Work Order ID 158746

D3016-041 SEAT FRAME ASSEMBLY

DRAWING NO. D3016	TITLE SEAT FRAME ASSEMBLY	REV. A	DART AEROSPACE LTD ENGINEERING ORDER	D.E.O. NO. D3016-A-1	SHEET NO. SHEET 1 OF 1	SCALE NTS
DRAWN 1	CHECKED UP	MFG. APPR. RE	APPROVED WAP	DE APPR. TH		
DATE 10.01.29	DATE 10.01.29	DATE 10.01.29	DATE 10.01.29	DATE 10.01.29

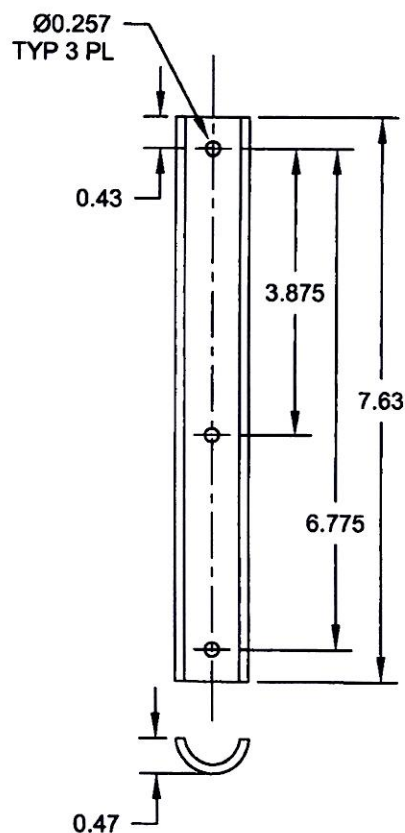
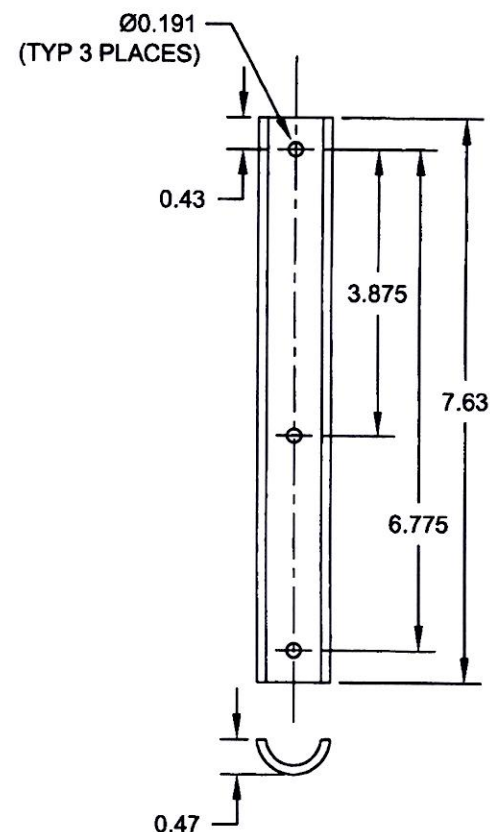
TO REVISE D3016-11 SADDLE'S HOLE SIZES

DETAIL D3016-11 SADDLE (SHEET 3): Ø0.257 TYP 3 PL WAS Ø0.191 (TYP 3 PLACES) AS SHOWN:
